**Town of Nags Head Planning Board
Nags Head Municipal Complex Board Room
Tuesday, November 19th, 2024; 9:00 a.m.**

Subject: Site Plan Review, 105 W. Seachase Drive

Purpose/Request: Construction of an approximately 8,305 square foot Dare County Emergency Management Services (EMS) station and all associated site improvements. Note that "Future Additions" are not included as part of the Site Plan Review.

SITE PLAN PRELIMINARY

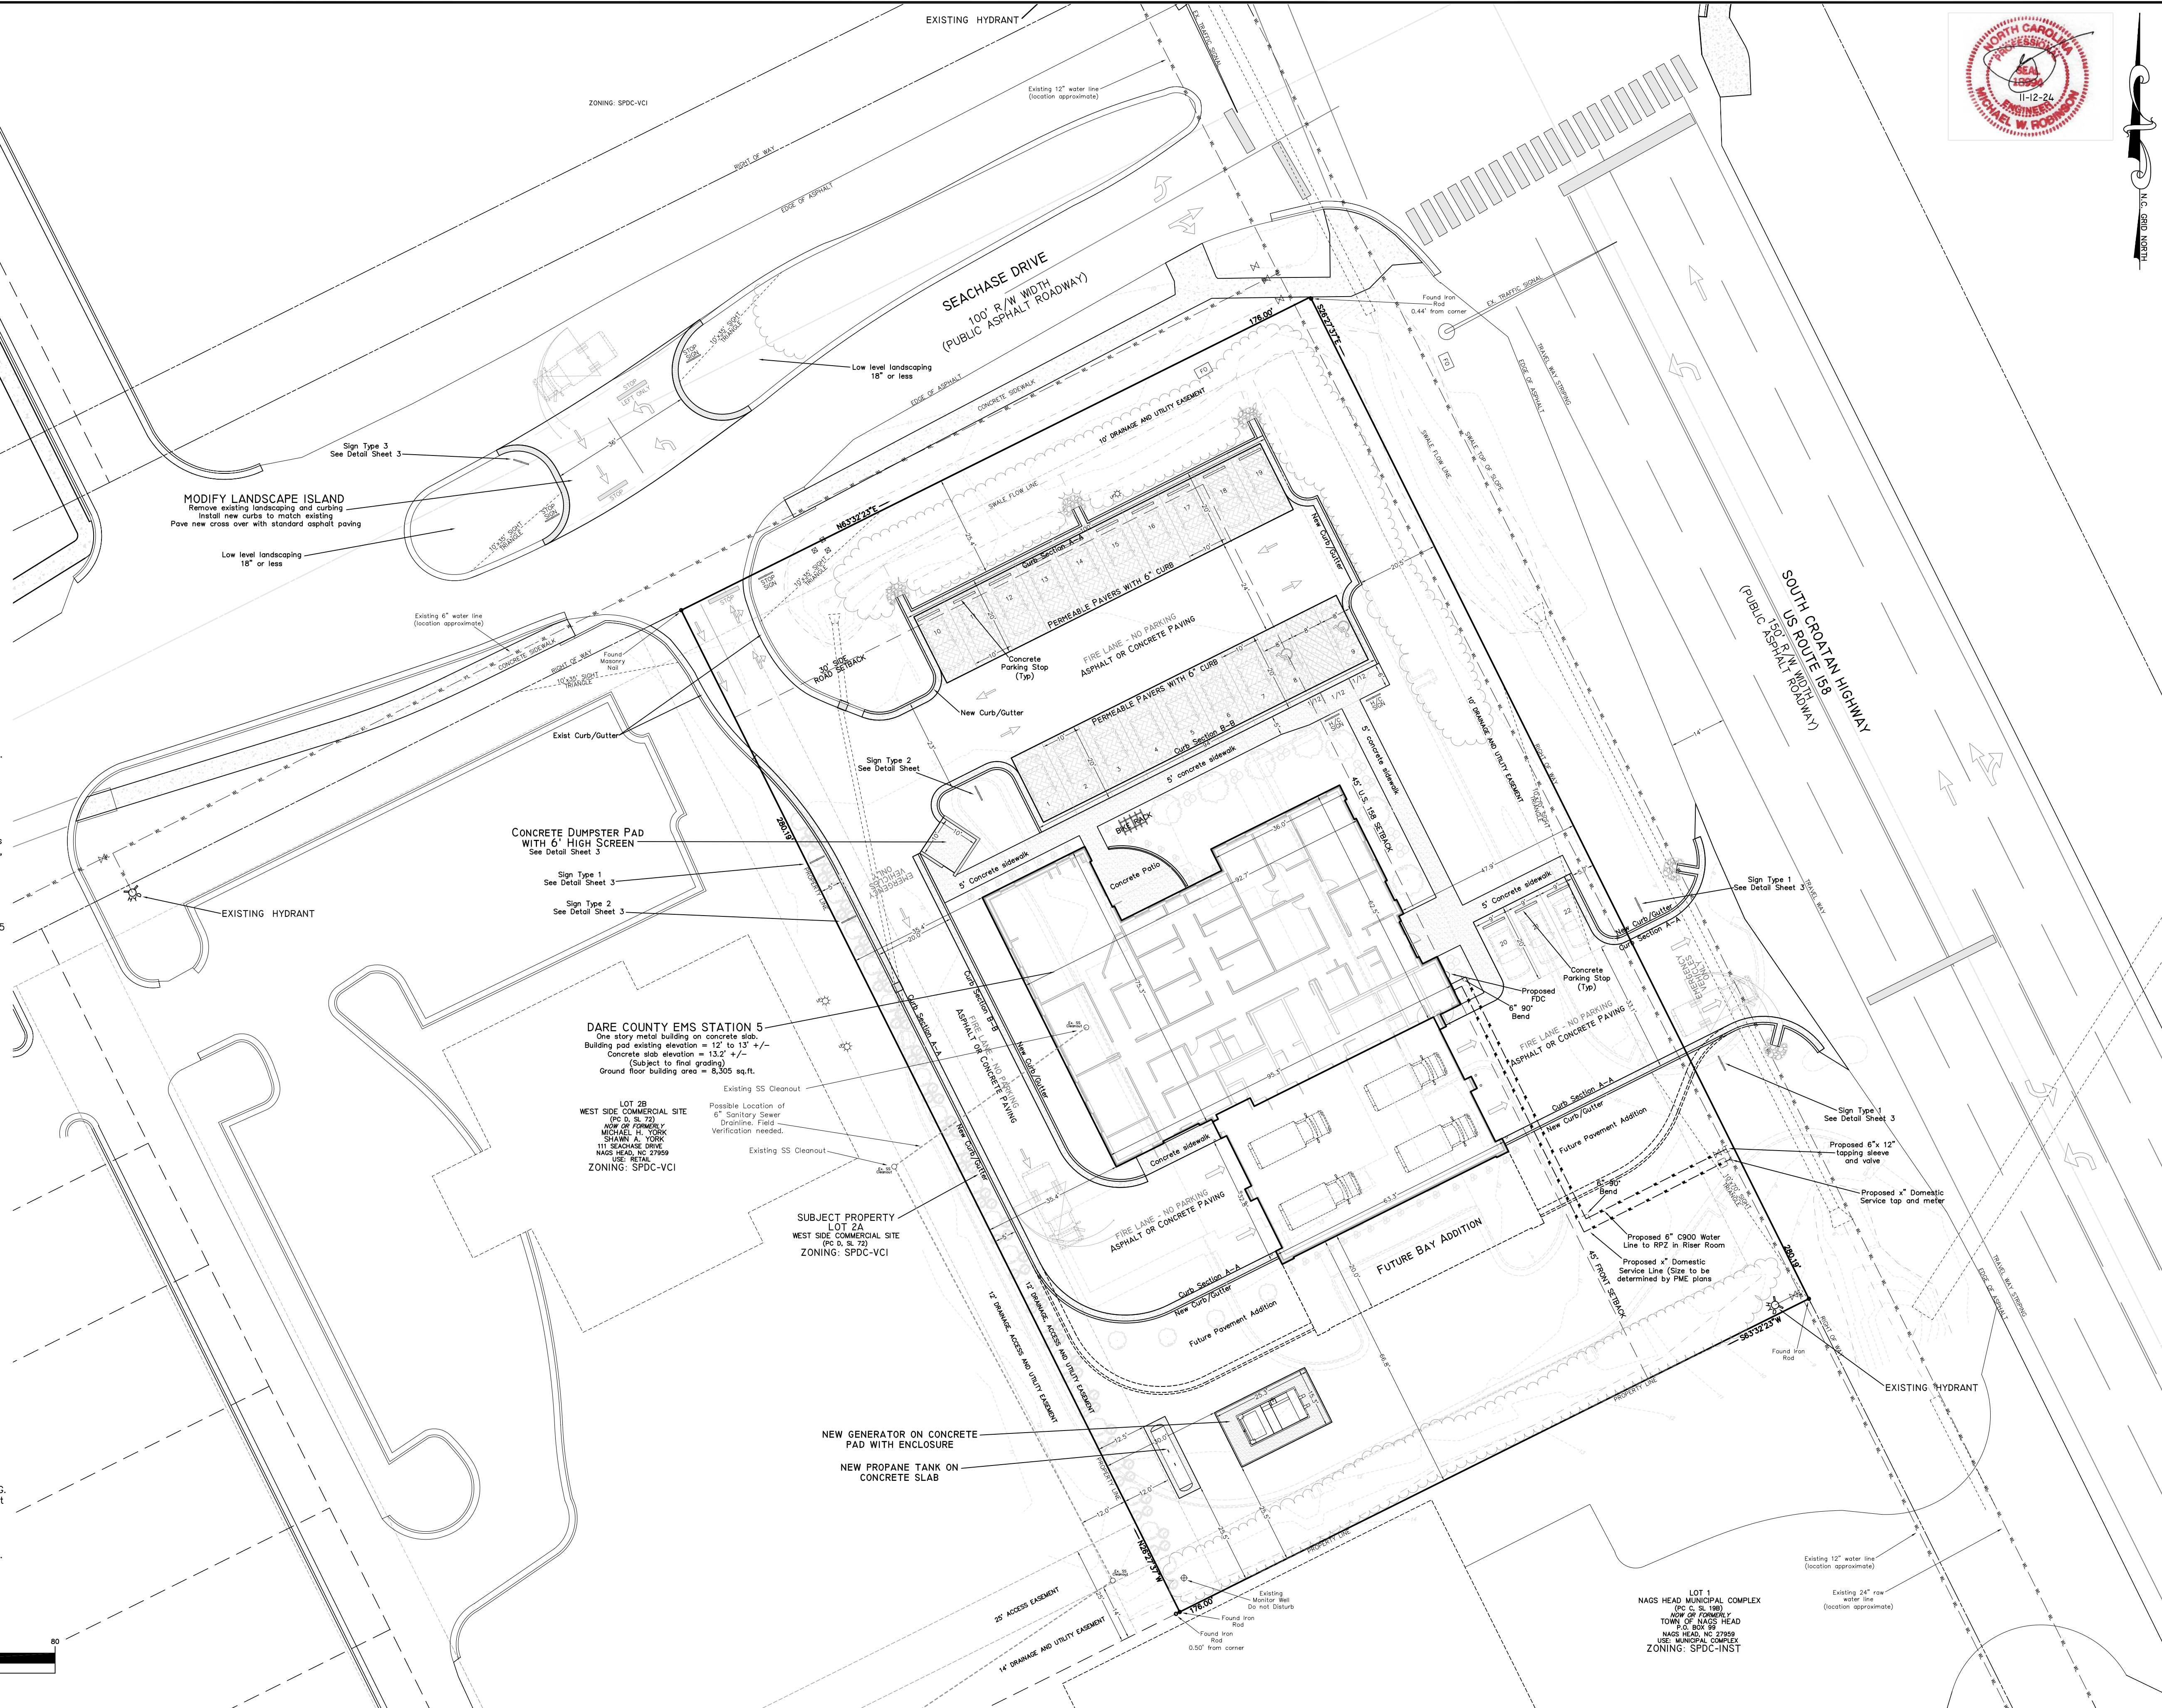
- Parking: At their November 6, 2024, meeting the Board of Commissioners adopted a parking standard for EMS Stations of one (1) parking space per employee on duty and one (1) parking space per 200 square feet of training facility and customer service areas. The applicant has noted a maximum of 12 employees at shift change, requiring 12 parking spaces, no training areas and approximately 100 square feet of customer service area, requiring one parking space. This use is required to have a minimum of 13 parking spaces, 22 spaces have been provided, therefore parking is compliant.

Section 9.21.7.14, General Provisions with the Village Commercial-1 District states that a buffer shall be maintained along property lines abutting any neighboring lots not a part of the shopping center (implying C-1 designation). The buffer shall be a 50-foot-wide grassed open space or a vegetated buffer of a minimum width of 5 feet that will reach a minimum height of 10 feet within five years. Sheet 2 of 5 of the Site Plan review packet demonstrates compliance with this provision, including preserving and maintaining a significant stand of mature vegetation along the southern property boundary.

Section 10.93.3.8 of the UDO, Vegetation Preservation/Planting Requirements, requires that new development projects either preserve a minimum of ten (10) percent of the lot's total area with existing natural vegetation and/or dune elevations or plant new vegetation in lieu of preservation. When existing vegetation cannot be preserved, the planting of a minimum of fifteen (15) percent of the lot's total area shall be required. The applicant has proposed to preserve all the existing mature vegetation onsite, resulting in 11% of the total lot area, in addition to the proposed new plantings, therefore vegetation preservation requirements are compliant.

- Lighting: A lighting plan compliant with the requirements of Article 10, Part IV of the Unified Development Ordinance will be required prior to the issuance of any development permits. In addition, a light audit will be required prior to issuance to occupancy permits.
- Signage: No additional signage is being proposed at this time.

Based upon staff's review of the proposal, we recommend approval of the Site Plan Review as submitted. Note this recommendation does not include approval of any future additions as shown. Any future additions will require a Site Plan Amendment consistent with the regulations in place at that time.
